**REMARKS**

This Amendment is being filed in response to the Office Action mailed February 24, 2005. Claims 14-18 have been withdrawn. Claims 1-13 were rejected. Applicant has amended Claims 1 and 9, and added Claims 20-23. Thus, Claims 1-13 and 20-23 are pending in the application.

**Amendments to the Drawings:**

FIG. 9

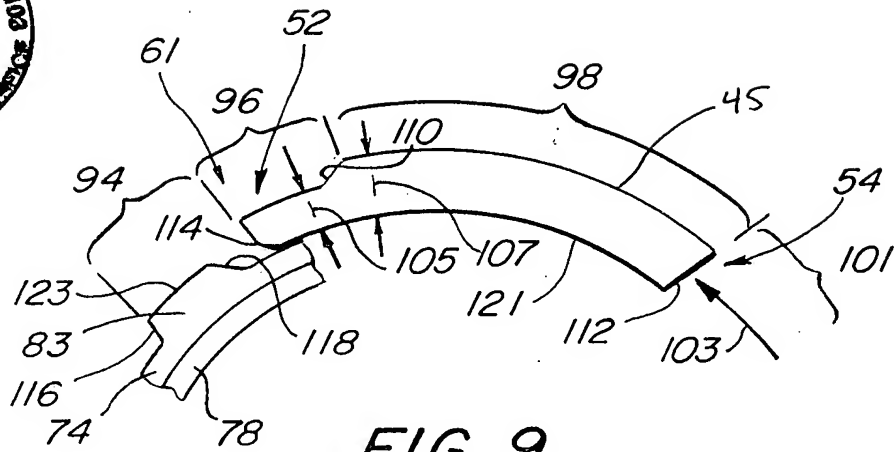
The attached sheet of drawings include changes to Figure 9. This sheet, which includes Figures 9-13, replaces the original sheet including Figures 9-13. In Figure 9, numeral "45" has been included to indicate the deflecting wall 45 .
